**RECORD
DOCUMENTS**

**POND GRADING
PLAN**

C7.4

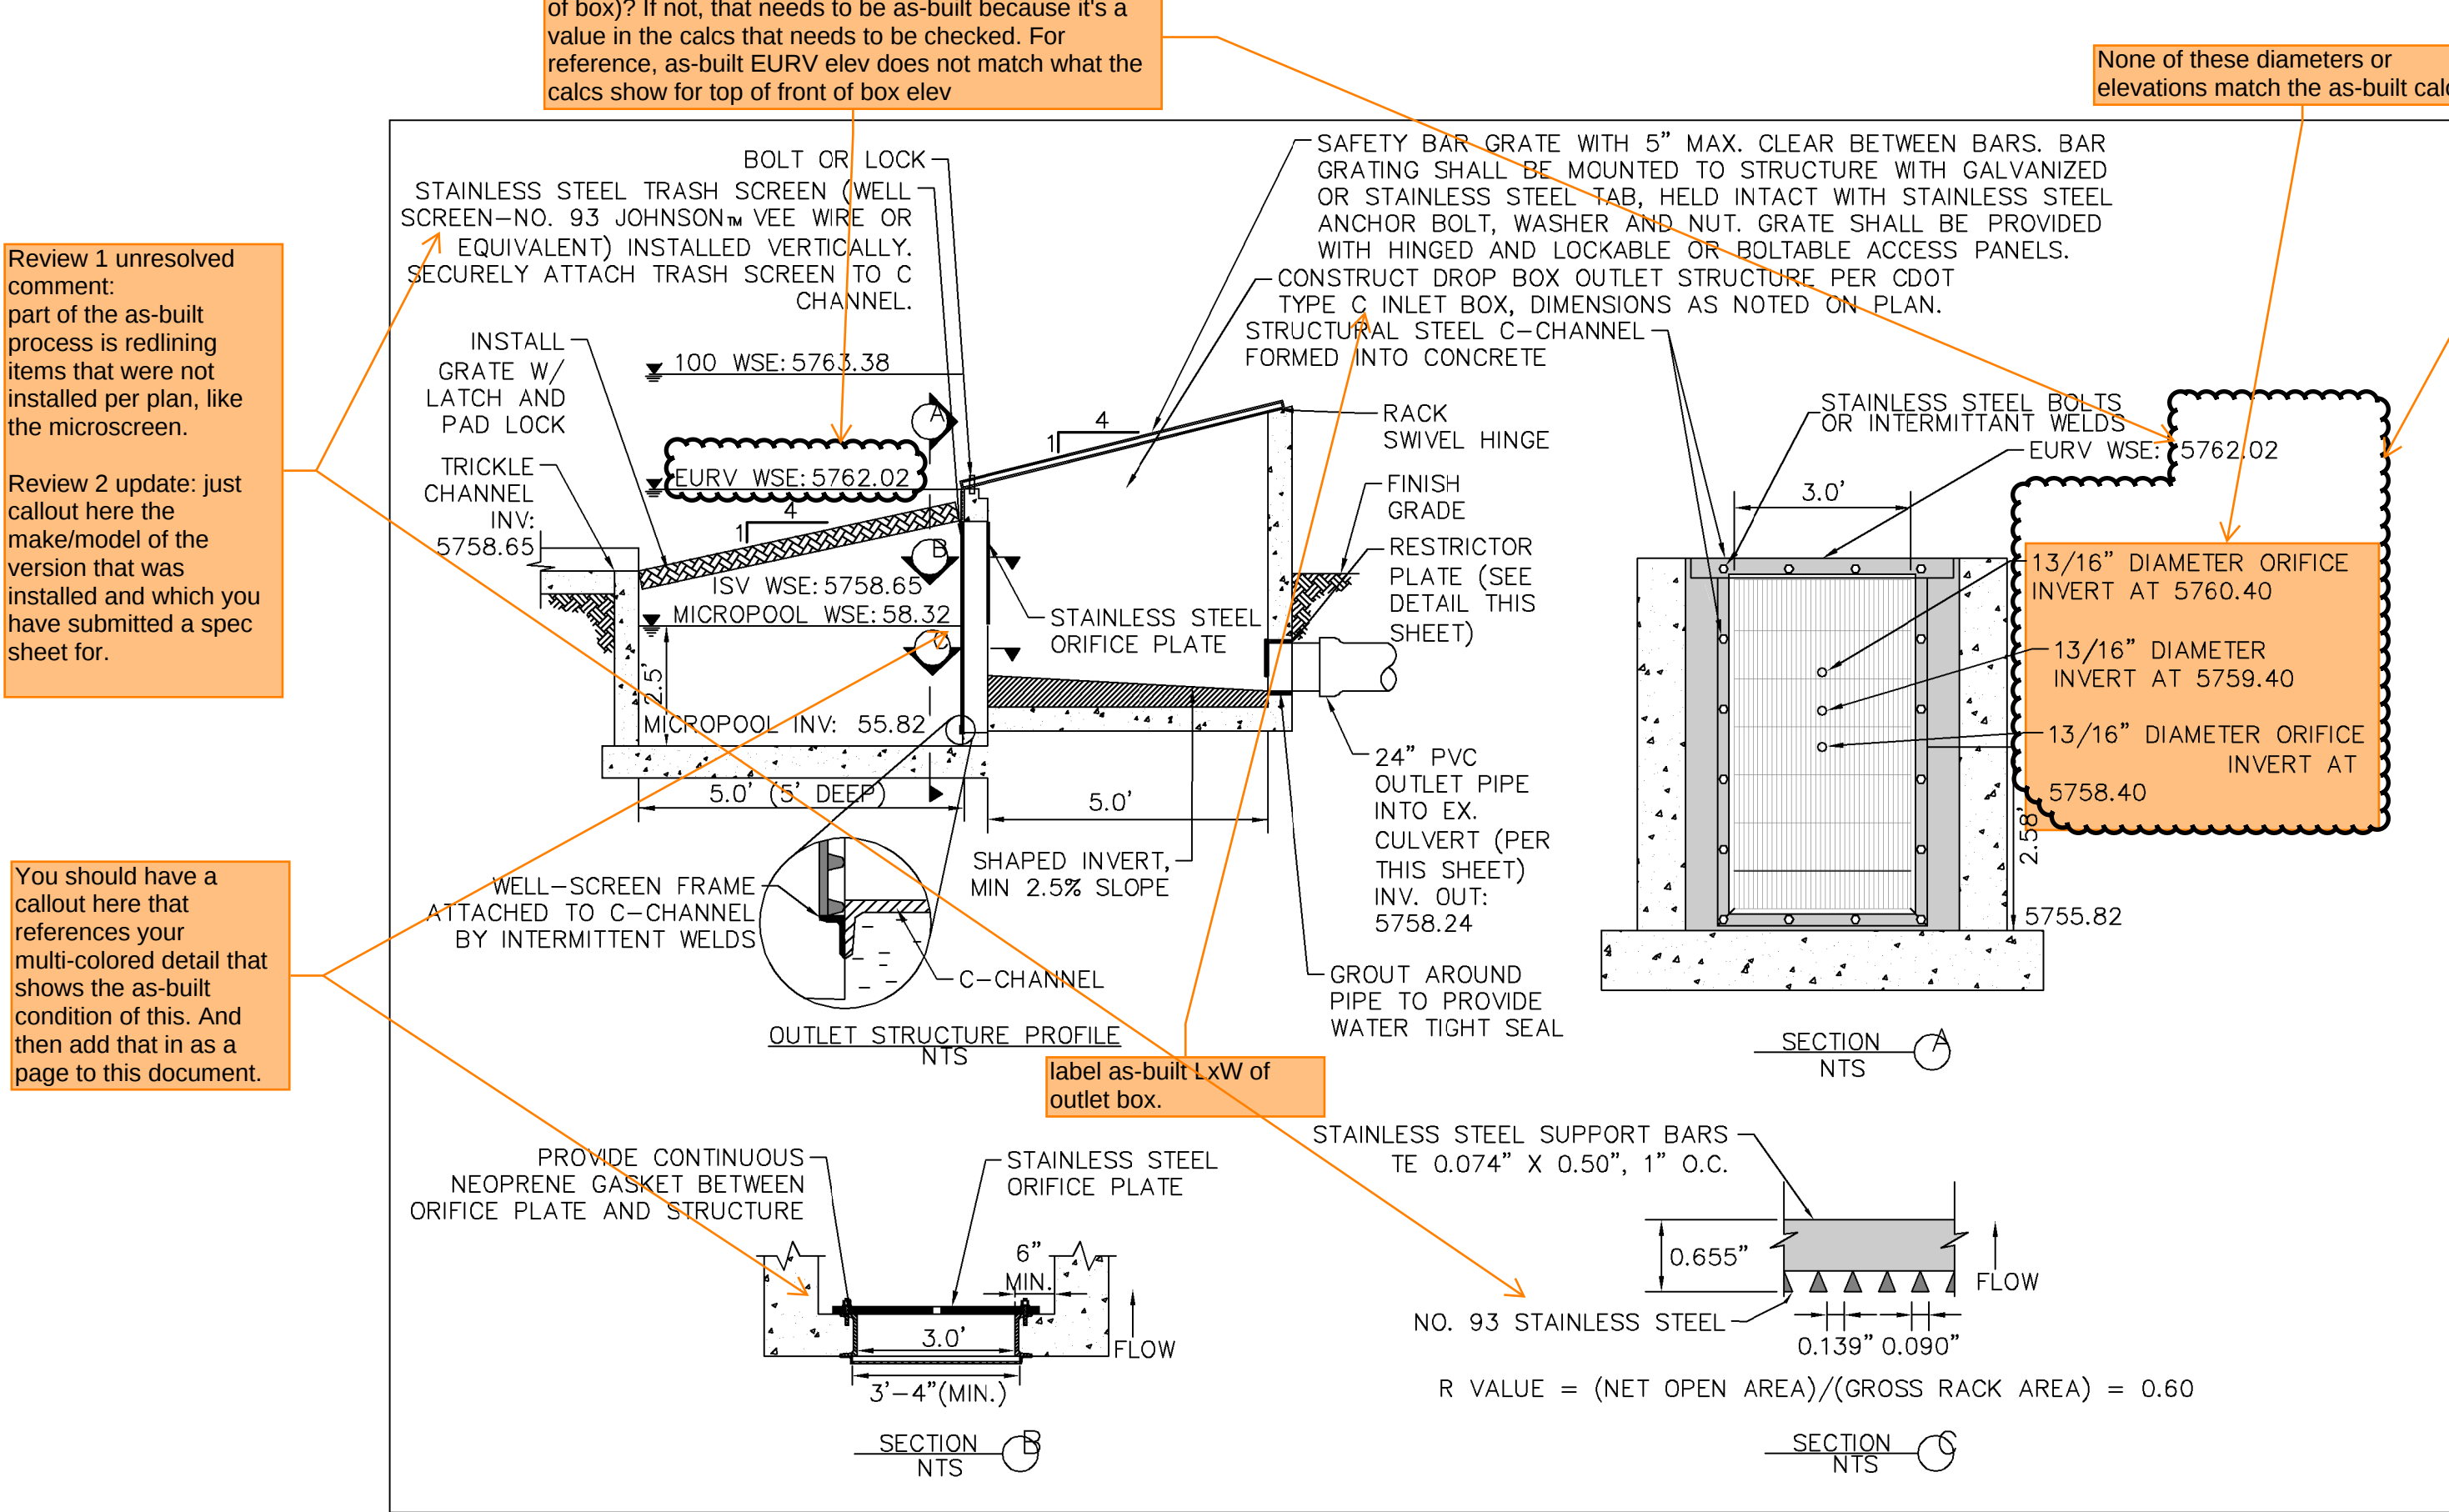
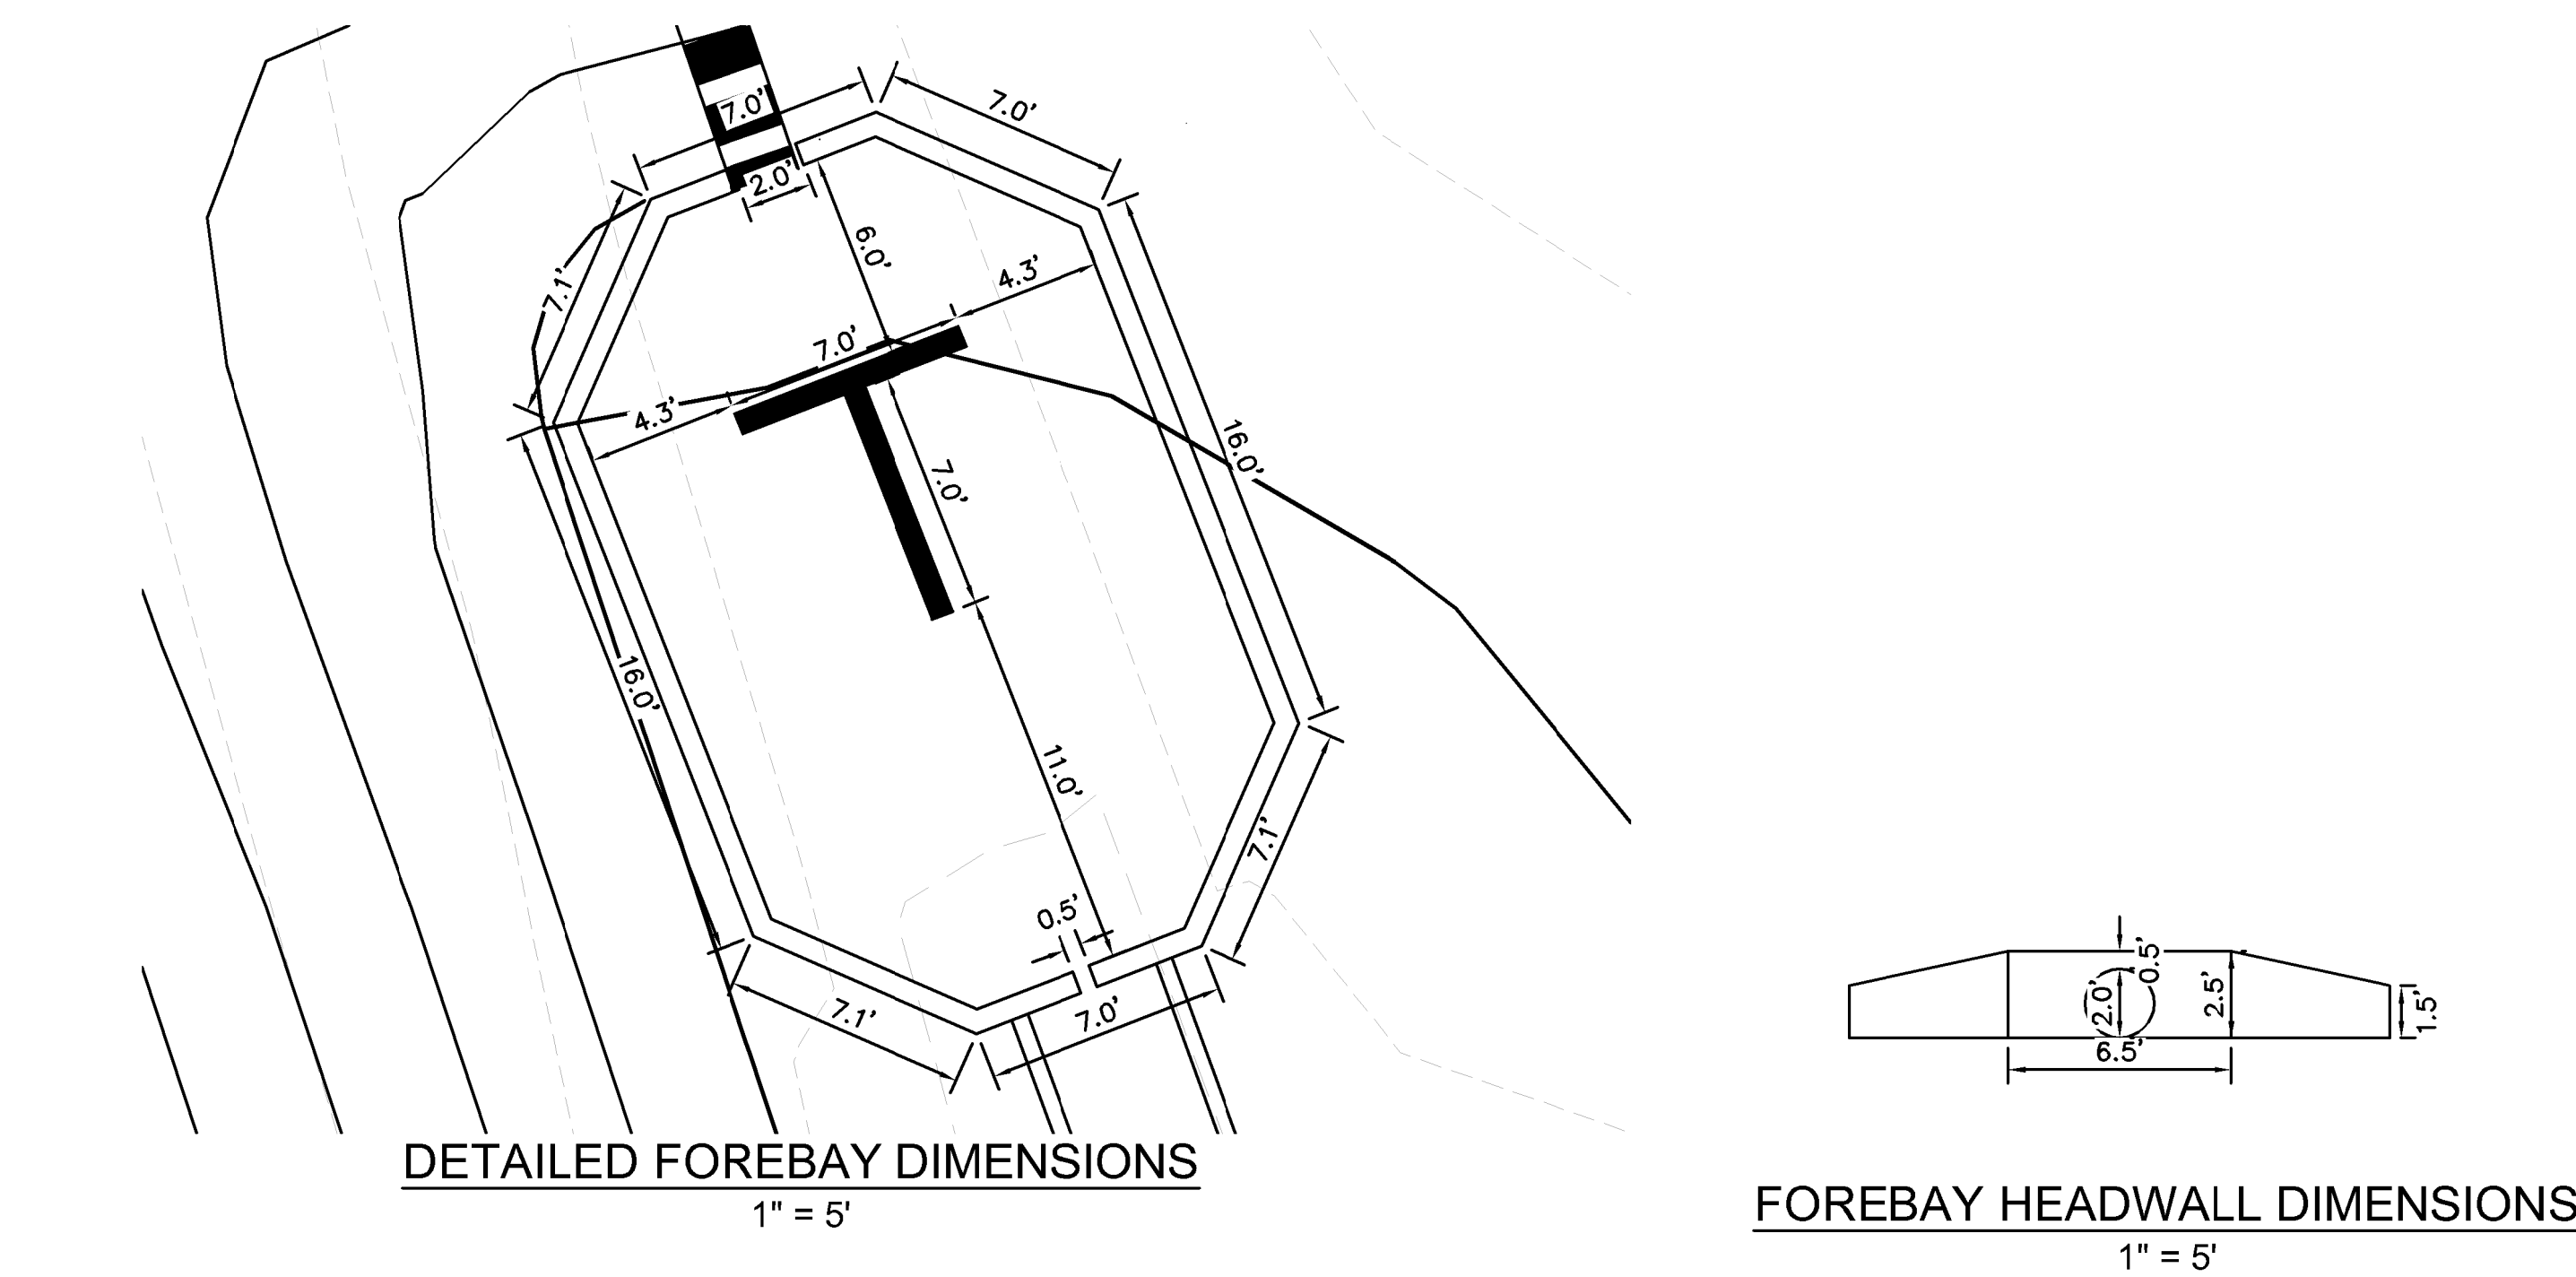
Grade overflow weir per detail

Grade this area per plan

This is the emergency overflow path that needs to be defined. If the pond overflows, water needs to be directed to the public ROW/street.
